ATMEL

## Circuit Analysis Report

Test IC	AT86RF231	
Crystal	Holder	NX5032GA
	Frequency	16.000MHz
	Load capacitance	CL=8pF (Current) <b>CL=10pF (Suggested)</b>
	NDK Spec. No.	STD-CSK-8(J) (*J:CL=10pF)
Test Circuit	IC	ATRF231 58901-03 1114 PH 0T7966-1
	VDD	+3V / +1.8V
	PCB	TB3_XMEGA_231 AVR2067 - Crystal Characterization for AVR RF

### 2. CIRCUIT DIAGRAM

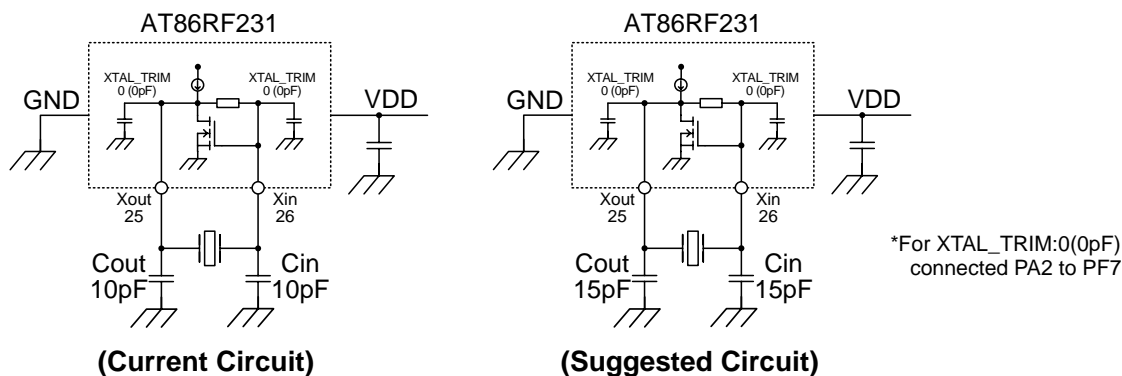
- 1) This crystal unit requires negative resistance of  $-R = 700\Omega$  minimum for stable oscillation
- 2) Circuit characteristics

- 3) Although the negative resistance of the current circuit is over our target, it seems too large.
- 4) In order to improve negative resistance, we recommend changing external capacitance values from Cout/Cin=10pF/10F to **Cout/Cin=15pF/15pF**. Besides, we recommend changing crystal load capacitance value from CL=8pF to **CL=10pF** in order to improve frequency deviation.

Circuit	Cout/Cin	XTAL_TRIM (Internal Cap)	Frequency deviation dF/F	Negative Resistance -R	Drive Level DL	Startup time Tstr
Current	10pF/10pF	0 (0pF)	+12ppm (CL=8pF)	3170 $\Omega$	Less than 10uW	1ms
Suggested	15pF/15pF	0 (0pF)	<b>+2ppm (CL=10pF)</b> Ref.: -36ppm (CL=8pF)	1890 $\Omega$	Less than 10uW	1.5ms
